QUALITY VALIDATION (QV) REPORT

Red Hill Bulk Fuel Storage Facility Defuel

Validation Firm	HDR Environmental, Operations and Construction, Inc.		Repair No.	006	
Address	9781 S. Meridian Blvd., Suite 400, Englewood, CO 80112		Repair ID	(b) (4)28	
Contract No.	FA890315D0007, D.O. FA8903-19-F-0027		Report Date	25 MAY 2023	
QV Engineer	(b) (6) ■ ■ ■ ■ ■ ■	Phone	(b) (6) ■ ■ ■ ■ ■ ■	Email	(b) (6) ■ ■ ■ ■ ■ ■@hdrinc.com

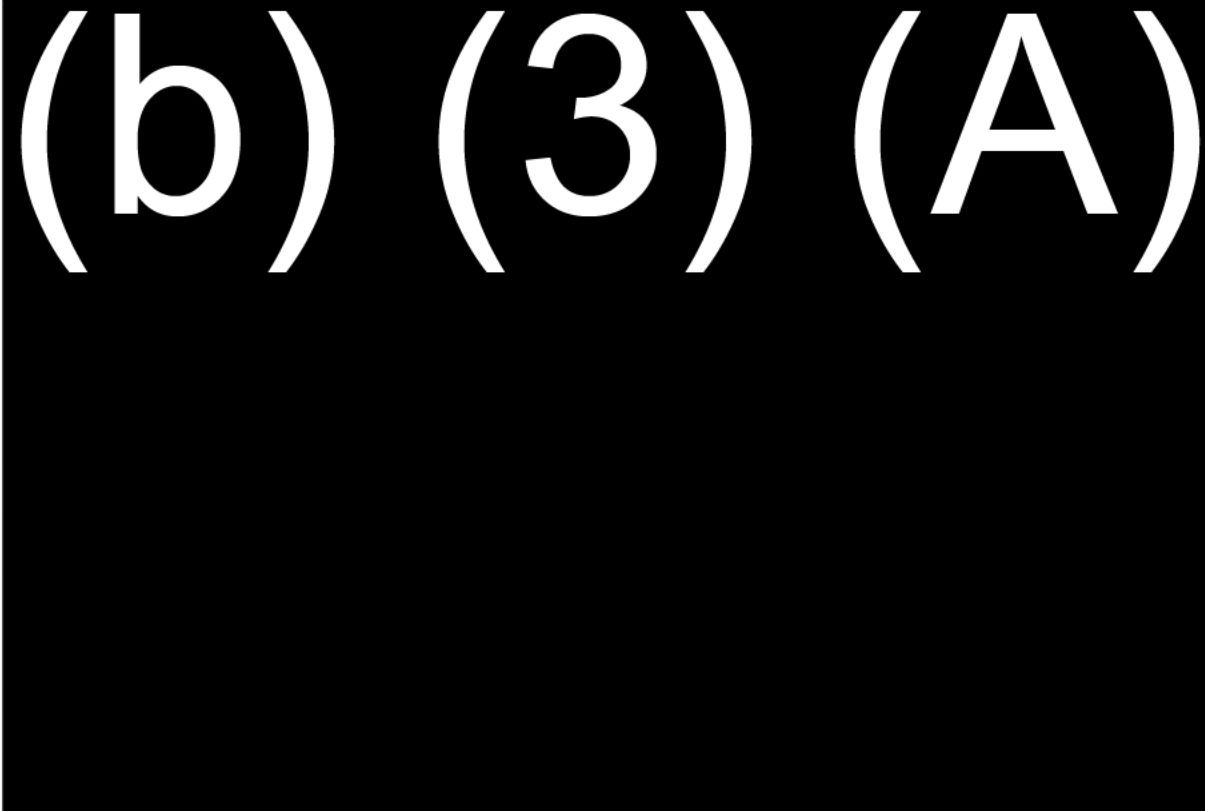
Flange missing fasteners, with uncapped pipe nipple.

Flange connection will not be used for defueling, therefore the repair was modified to install a blind flange with new fasteners instead of replacing fasteners on the existing flange and capping pipe nipple.

New blind flange installed with no pipe nipple penetration. All fasteners replaced.
